**Shire of**  
**Gunnedah**  
 Land of Opportunity

## MEETING NOTICE

<b>ITEM 1</b>	<b>Application to Modify a Development Consent No. 2015/062.004 – Modification to remove staging plan, change fencing material to steel and change lot configuration – Lot 24 DP1235089 – 131 Quia Road, Gunnedah</b>
<b>MEETING</b>	Planning, Environment and Development – 3 October 2018
<b>DIRECTORATE</b>	Planning and Environmental Services
<b>AUTHOR</b>	Town Planner
<b>POLICY</b>	Nil
<b>LEGAL</b>	Environmental Planning & Assessment Act, 1979 Gunnedah Local Environmental Plan, 2012 Gunnedah Development Control Plan, 2012
<b>FINANCIAL</b>	Nil
<b>STRATEGIC LINK</b>	Community Strategic Plan 2.4.5 Implement and advocate for planning strategies and systems that are streamline to foster and encourage the establishment of new business. Operational Plan 2.4.5.1 Ensure compliance with legislation through assessment of development applications
<b>ATTACHMENTS</b>	Nil

**ITEM 2                    Application to Modify a Development Consent No. 2015/054.002 – Modification to amend building envelope and Asset Protection Zone on Lot 5 – Lot 662 DP723481 and Lot 680 DP39633 – 229 Kamilaroi Road, Gunnedah**

Figure 1 – Site Plan

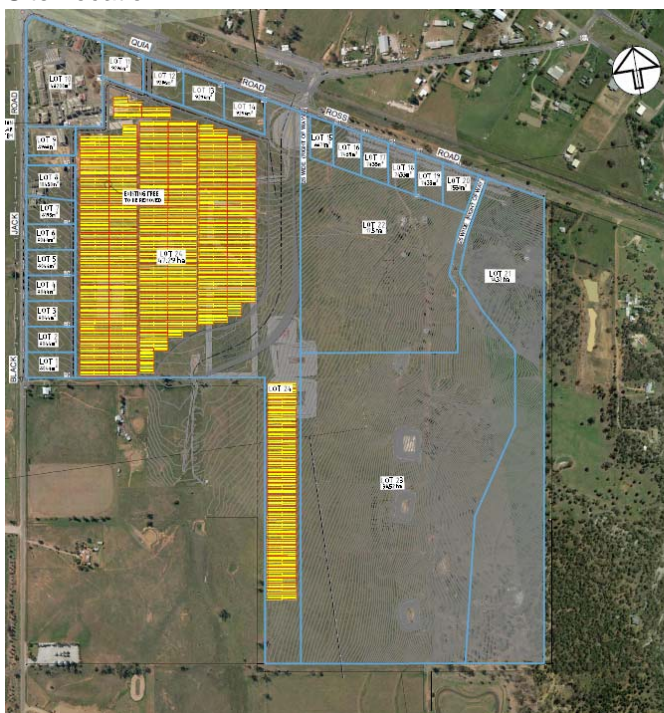
The Modification of Consent application is seeking consent to amend development plans to alter the lot layout, change the proposed fence around Lot 24 from being constructed of aluminium to steel and remove the staging plan and references to staging from conditions for the development.

The proposed modification will change the lot configuration of Lots 1-20 and 24. Lots 22 and 23 will be amended to reduce the area of Lot 22 and increase the area of Lot 23 to accommodate expected future development on these lots. The access handle to Lot 23 will be amended to provide access to Lot 22. The access handle to Lot 23 will be relocated to between Lots 21 and 20. There will be no foreseen conflict with the relocation of these access handles. Each of the access handles to these lots will be 25 metres or wider in width. The proposed amended lot configuration is not expected to result in any conflict with adjoining allotments and there is no linkage required between the resulting lots and the adjoining land that may be jeopardised by the proposed lot layout. The proposed alteration to the fence material from aluminium to steel is considered to have minimal impact.

That the Modification of Consent No. 2015/062.004, to modify the lot configuration, alteration of fence material from aluminium to steel and removal of staging plan, at Lot 24 DP1235089 – 131 Quia Road, be approved subject to the deletion of conditions A1b, A4, C1b, F5a, F5b, F6, F15, F21a, F21b, I8 and I9 and insertion of conditions A1c, C1c, F6a, F10a, F13a, F15a, I8a and I9a. Amended conditions underlined as follows:

Figure 1 – Proposed building envelope plan

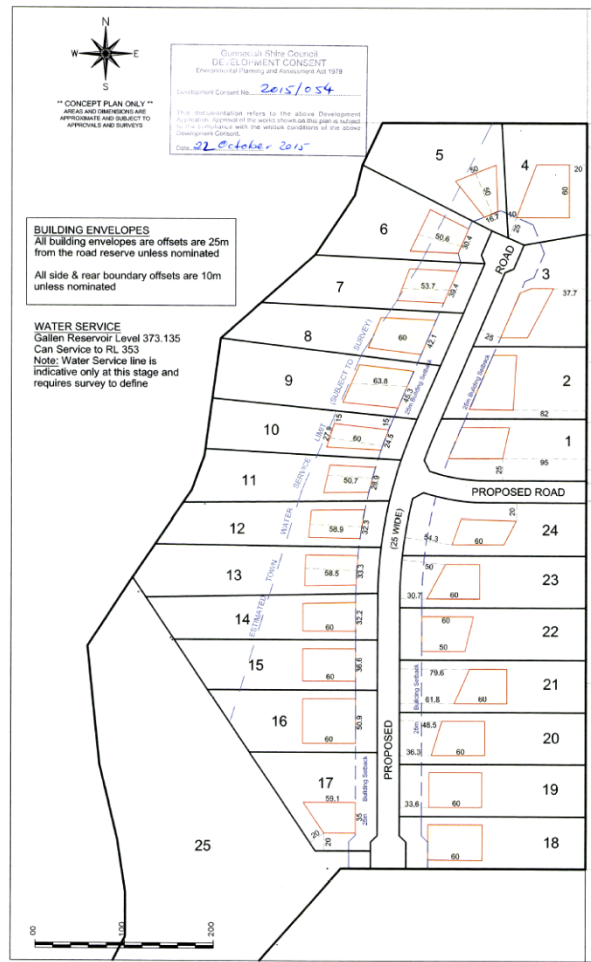
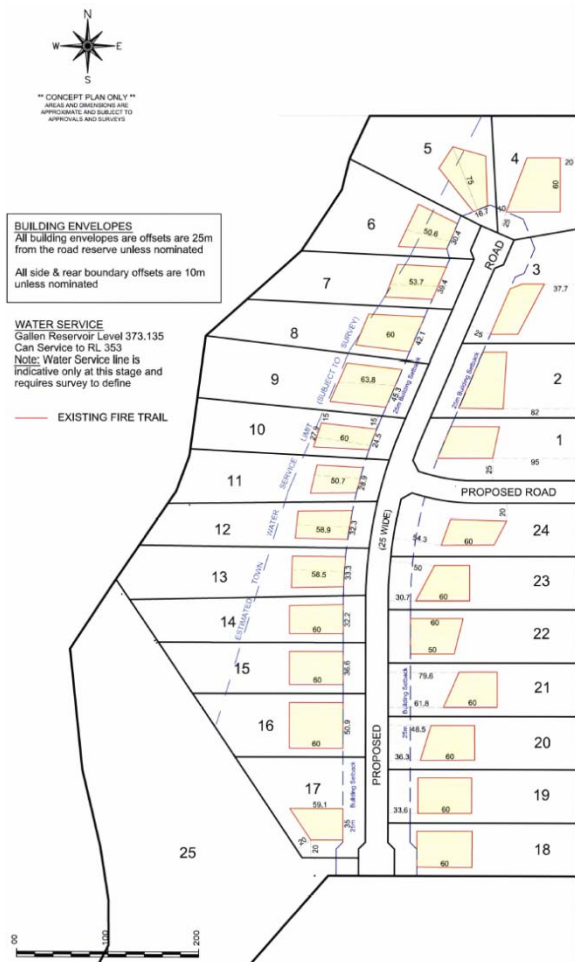
The Modification of Consent application is seeking consent to amend the building envelope and the position of Inner and Outer Protection zones within the Asset Protection Zone within Lot 5 of the approved subdivision.

The building envelope will be increase by an area of 430m<sup>2</sup>. The increase will enable any future dwelling construction to occur in such a position to avoid an existing gully which passes through the building envelope in its current shape. The building envelope adheres to required building setbacks as listed by Clause 2.1.1 of the Gunnedah Development Control Plan, pertaining to building setbacks for future developments.

That the Modification of Consent No. 2015/054.002, for the modification to the building envelope and Asset Protection Zone on Lot 5, at Lot 662 DP723481 and Lot 680 DP39633 – 229 Kamlaroi Road, be approved subject to the deletion of conditions A1, B1 and B4 and insertion of conditions A1a, B1a and B4a. Amended conditions underlined as follows:

Figure 3 – revised layout Lot 5

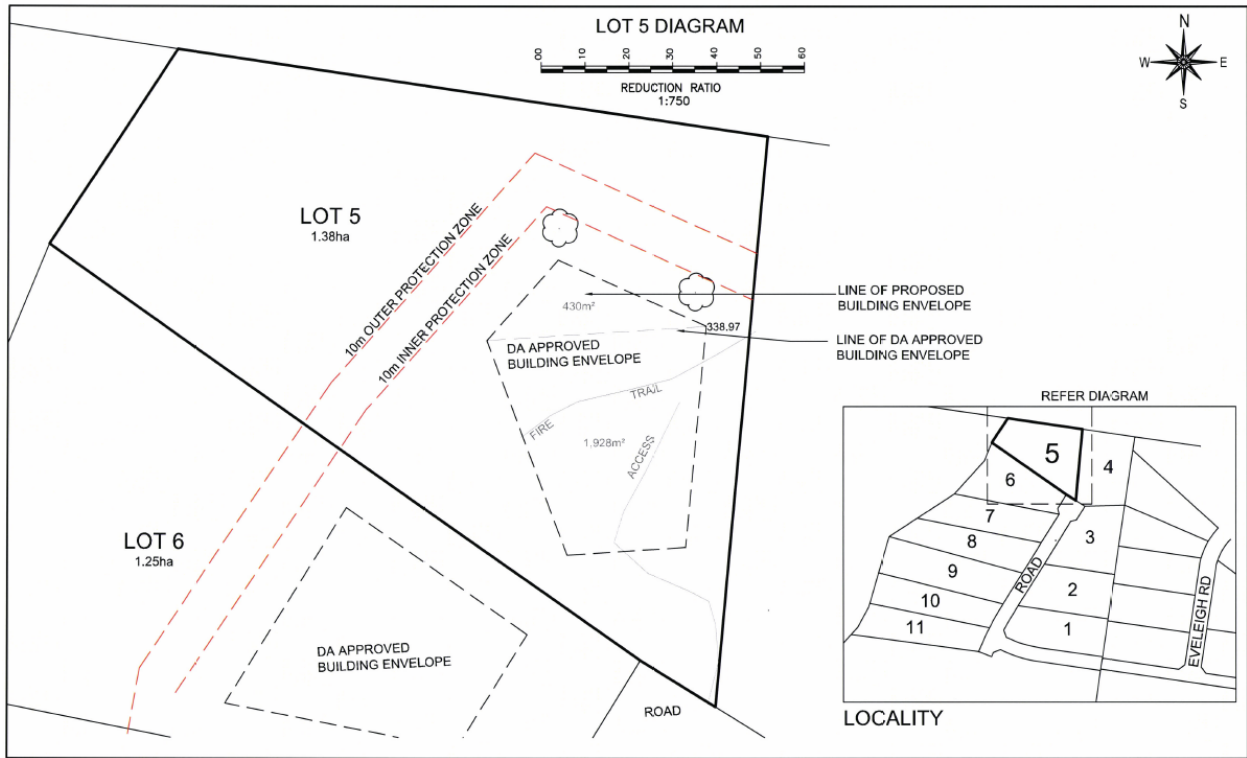
The Modification of Consent application proposes to change the position of the Asset Protection Zone (APZ) around the building envelope within Lot 5 to accommodate the increase in size of the building envelope. The APZ is made up of a 10 metre Inner Protection Area (IPA) and a 10 metre Outer Protection Area (OPA) in accordance with Section 4.1.3(3) of 'Planning for Bush Fire Protection 2006'. The relocation of the APZ will require further clearing of vegetation from the site enable the establishment of the IPA and OPA. Existing shrubs and low vegetation, such as Wilga Trees, is to be thinned out to around 30% of the current coverage to ensure compliance with Section 4.1.3(3) of 'Planning for Bush Fire Protection 2006'. The vegetation to be cleared will not include any box trees or Koala Feed Trees. The removal of the vegetation will not detract from the ecosystem or impact on the areas of habitat. Hence, the removal of this vegetation is considered to be acceptable.
